**SUNDRY NOTICES AND REPORTS ON WELLS**  
*Do not use this form for proposals to drill or to re-enter an abandoned well. Use form 3160-3 (APD) for such proposals.*

Salado Draw Pad 18

Chevron USA Inc respectfully requests authorization to add a 20' x 61.88' access road to the entrance of Salado Draw Pad 18.

CHEVRON U.S.A. INC.  
PROPOSED ACCESS ROAD  
SALADO DRAW PAD 18  
SECTION 14, T26S-R32E  
LEA COUNTY, NEW MEXICO

SURFACE USE PLAT

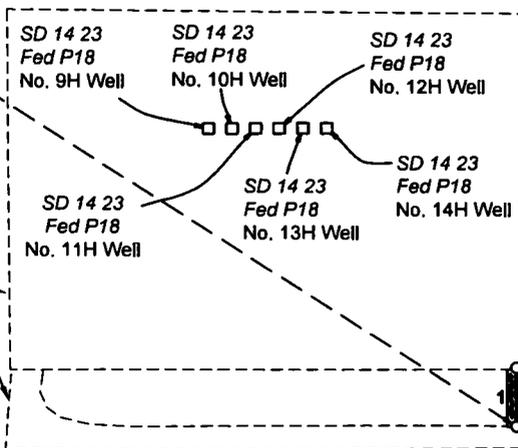
Justification: The Chevron Completions team recently completed a review of their safety procedures during well completions and identified as a gap the lack of 2-access roads. In the event of an emergency requiring evacuation, the single access road restricts traffic and limits the pace in which the evacuation can occur. The 2nd access road allows for egress in the event of an emergency for the Completions Team and will be reclaimed after the Pad's wells have been completed.

CENTERLINE PROPOSED  
ACCESS ROAD  
20' x ±61.88'  
±3.75 Rods  
±0.03 Acres

*PCW*  
*11/01/19*  
*Same COAs ADH*
